APPLICATION NO.	FILING DATE	FIRST NAMED INVENTOR	ATTORNEY DOCKET NO.	CONFIRMATION NO.
10/529,002	12/15/2005	Joachim Haedicke	2002P00990WOUS	8810

Office Action Summary	Application No. 10/529,002	Applicant(s) HAEDICKE ET AL.	
	Examiner KWOK C. WONG	Art Unit 4156

DETAILED ACTION

3. Figures 4 & 6 (below) from Kolze et al. discloses the elements of Claim 14 as follows:

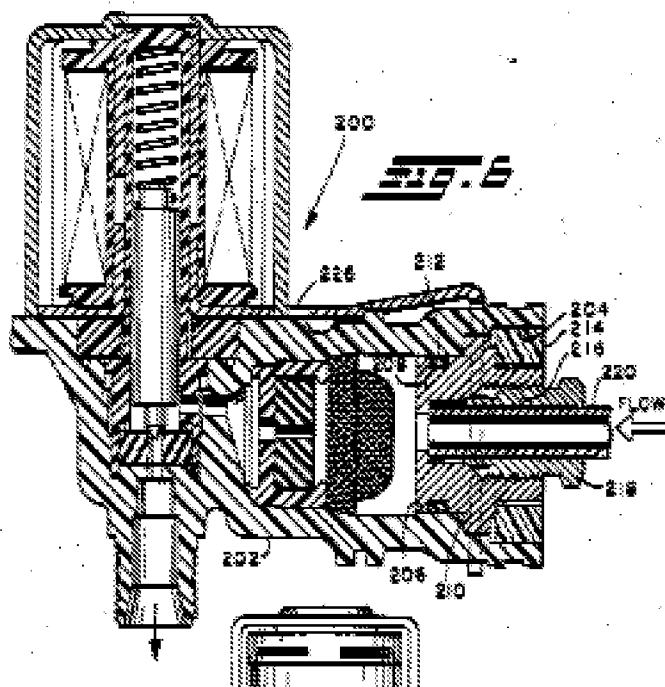
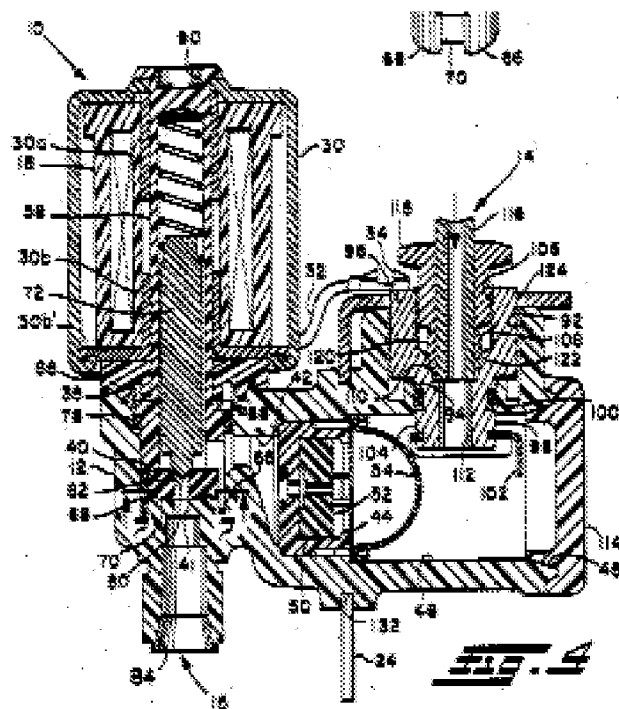
A gas tap (as seen in Figs 4 & 6) including a gas path (as seen in Figs 4 & 6), comprising:

said safety valve including an armature housing (as seen in Figs 4 & 6) and having

a mobile magnetic anchor in said housing [Column 5, Line 30; as seen in Figs 4 & 6];

4. In Claim 15, Figures 4 & 6 of Kolze et al. show the electromagnetic coil arranged separate from the gas path.

5. In Claim 16, Figures 4 & 6 of Kolze et al. show the electromagnetic coil outside of the armature housing and is able to be detached.

6. In Claim 17, Figures 4 & 6 of Kolze et al. show the electromagnetic coil outside of the gas tap.

7. In Claim 18, Figures 4 & 6 of Kolze et al. show the electromagnetic coil partially protruding outside of the gas tap.

8. In Claim 23, it can be seen from Figures 4 & 6 of Kolze et al. that the armature housing has one section set inside the gas tap and another section projecting from the gas tap.

9. In Claim 24, Figures 4 & 6 of Kolze et al. show a portion of the armature section set inside of the gas tap similar in structure to that of housing sections of a magnetic insert.

10. Figures 4 & 6 (above) from Kolze et al. discloses the elements of Claim 26 as follows:

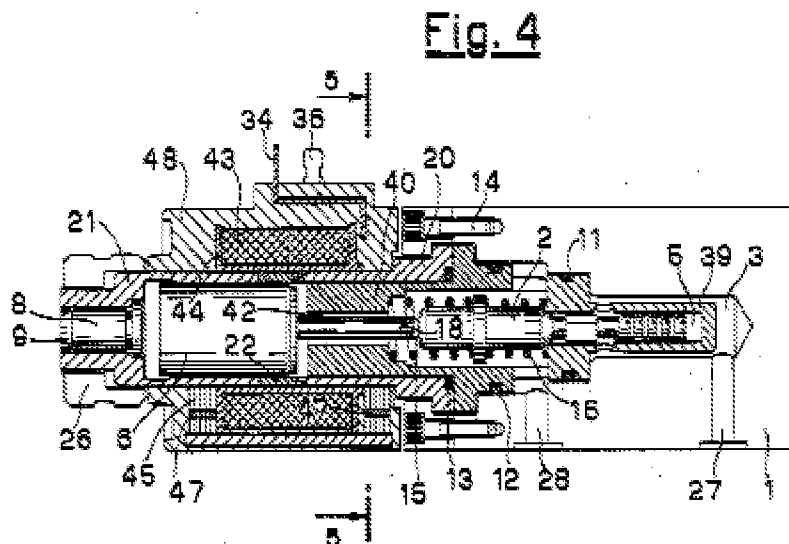
In Claim 20, Tirelli '399 [Column 6, Lines 18-31] teaches the use of an anchor guide section positioned inside of a gas tap for sealing engagement and an anchor guide section positioned outside of the gas tap as shown in Figure 4 of Tirelli '399 below.

In Claim 25, Tirelli '399 [Column 5, Lines 9-13; Column 6, Lines 32-43] teaches the use of counter-anchor as a device to attract (or repel) the magnetic anchor (armature) via a magnetic field as a result of an electric current applied to the electromagnetic coils. It is clear from Figure 4 above that at least one of electromagnetic coil, armature housing sections, counter-anchor are provided on a second armature housing section projecting from the gas tap.
